Subject: Response to Conditional Work Plan Approval (ACDEH, July 7, 2017)
City Blue Print, 1700 Jefferson St., Oakland, CA 94612
Fuel Leak Case RO0000151 and Geotracker Global ID T0600100196

AWR prepared this letter on behalf of ARC to respond to ACDEH's "Conditional Work Plan Approval", July 7, 2017, which commented on AWR's "Additional Investigation Work Plan for 581 18th Street, Oakland, California", July 7, 2017 (hereinafter referred to as "Work Plan"). To aid the reader, this letter incorporates verbatim, and in [smaller blue font](#), the key text from the ACDEH Conditional Work Plan Approval and our responses are indented below each comment.

Responses to ACDEH's "Conditional Work Plan Approval", July 7, 2017

Figure 1
**Revised Proposed
 Sampling Locations**

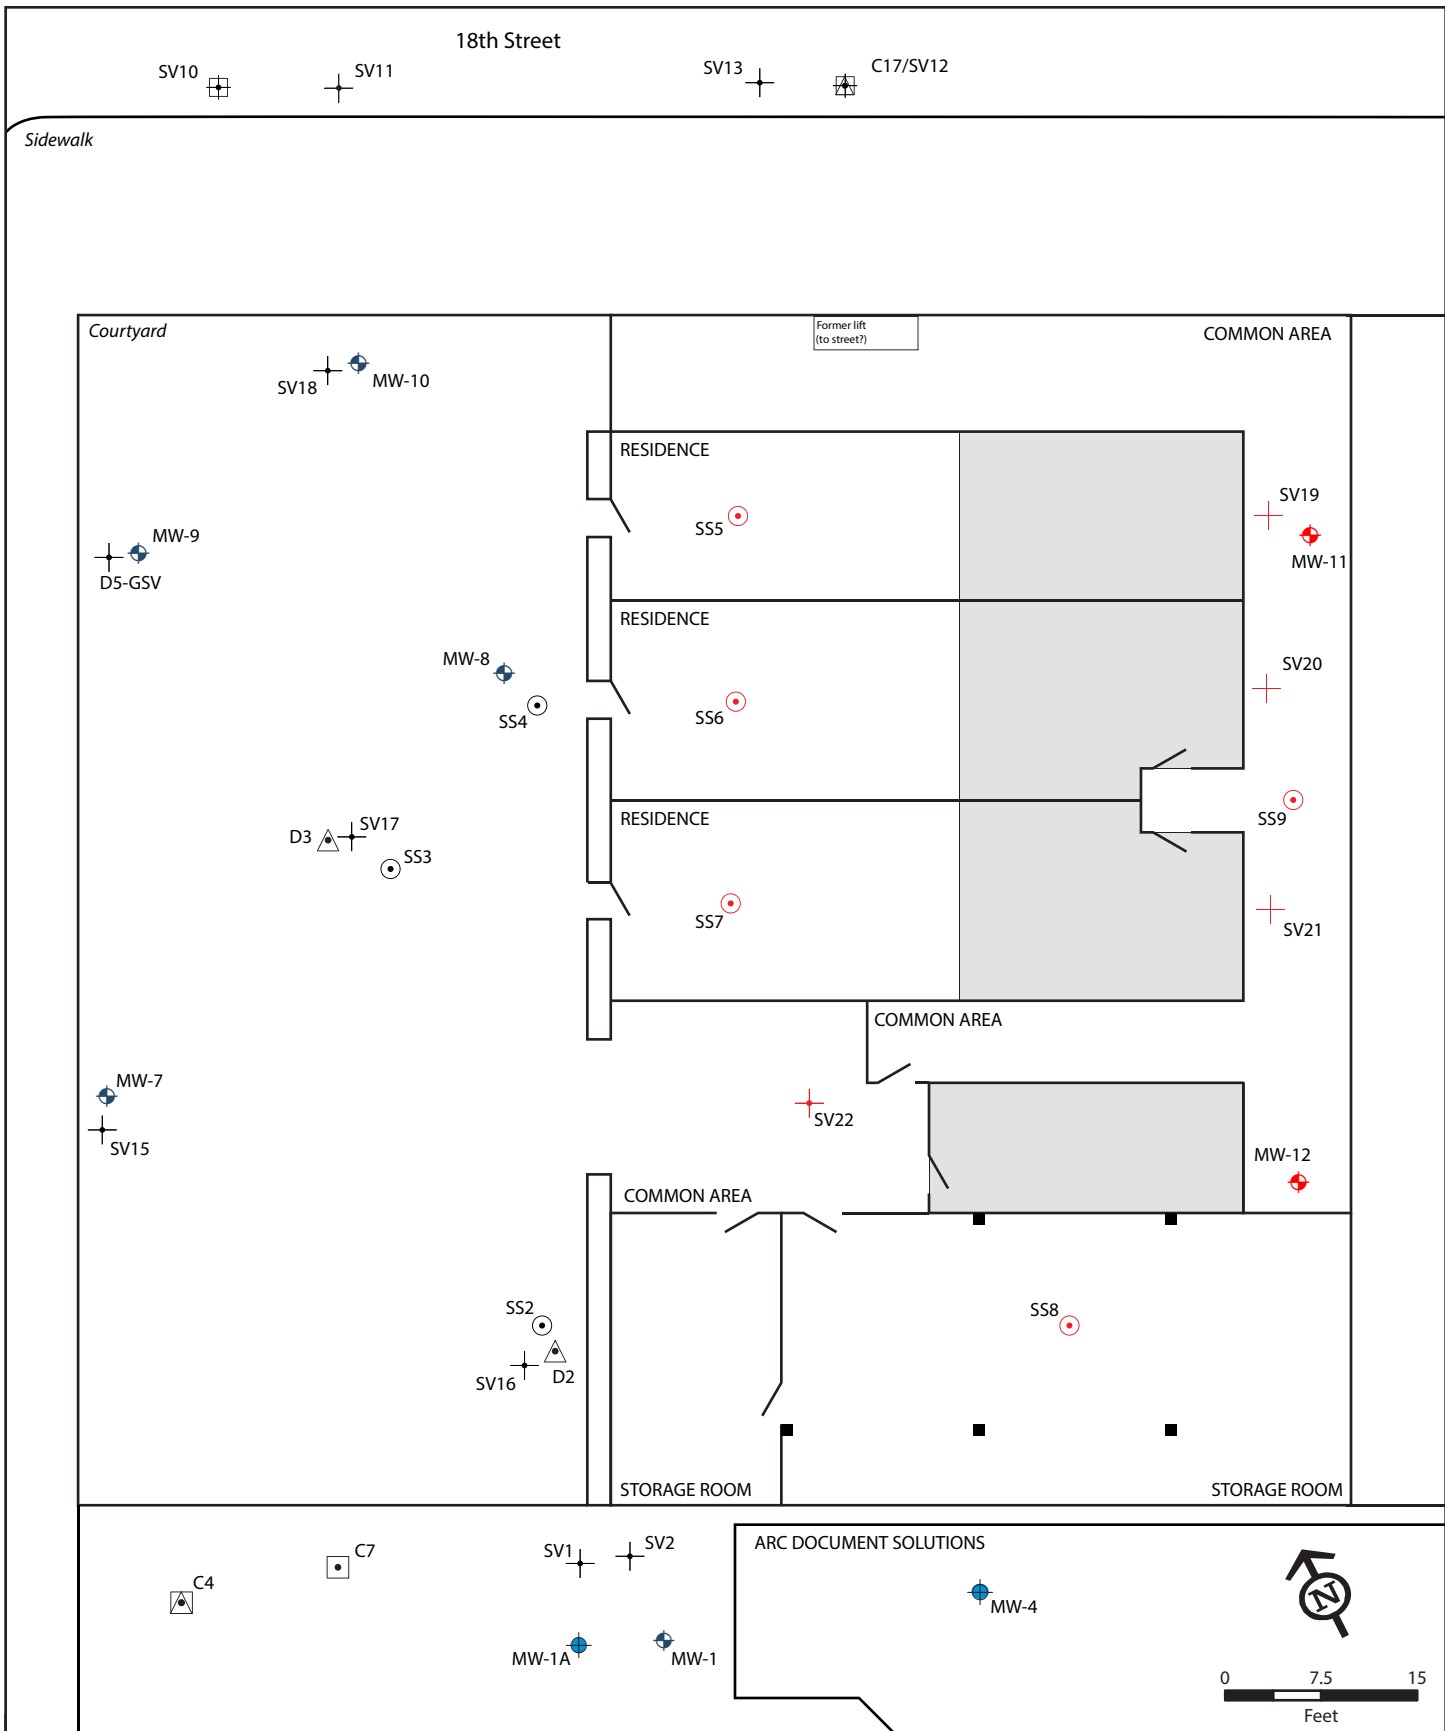
Contingency Indoor Air Sampling – In the event that indoor air samples are appropriate, ACDEH is in general agreement with the collection of the proposed samples as described in the work plan (courtyard level and street level common area) as a first step; however, the sampling of additional floors may be necessary. In addition to mapping all levels, please identify stairs and any elevators which may act as conduits between levels.

Soil Sampling and Analysis – In an effort to define the extent of soil contamination, ACDEH requests the collection of intact soil samples from the proposed ground water monitoring wells and soil vapor wells. The collection of data within the 0 to 5 and 5 to 10 foot intervals may provide alternative means to understand the site; however, representative soil samples should be collected at major lithologic changes and signs of contamination (PID

- Location of the sub-slab samples, and possible subsequent indoor air samples, within the courtyard level residential units as described in the Work Plan, or outside the residential units as requested in the Terraphase Memorandum;
- Depth of the soil vapor samples within the deeper sandy zone that contains the water table, as described in the Work Plan, or within the overlying silty sand layer as requested in the Terraphase Memorandum;

- Installation and collection of ground water samples from two new monitor wells installed within the building as described in the Work Plan, or two grab ground water samples as requested in the Terraphase Memorandum;
- Standard laboratory turn-around time for the sub-slab vapor samples as described in the Work Plan, or expedited 24 hour laboratory turn-around as requested in the Terraphase Memorandum.

Based on the data and the evaluation of potential risk to the quality of indoor air, additional samples of indoor air will be collected in locations based on the layout of the building, as required to further assess potential risks to indoor air.

Physical access to the courtyard level with powered drilling equipment is problematic, because access is only by stairs and it is 13 feet below street level. Consequently, all drilling and sampling will be performed using manually operated equipment, similar to the recent courtyard sampling. As possible, we will collect soil samples using a manually powered piston driven core sampler as follows:

- Borings for the soil vapor wells:
 - Collect a soil sample immediately below gravel or sand fill (if present) underlying the building's concrete slab floor.
 - Collect soil samples from 4.5 to 5 feet below the bottom of the concrete slab. Based on prior investigations, this depth is expected to consist of silty sand, and is likely located just above the transition to the sand layer that contains the ground water table. The top of sand layer is expected to be from about 5.5 to 6 feet below the bottom of the slab. We note that the building slab appears to be at least 10 inches thick.
- Borings for the ground water samples:
 - Collect unsaturated soil samples between 5 and 10 feet below the bottom of the concrete slab, and within the sandy ground water bearing layer.
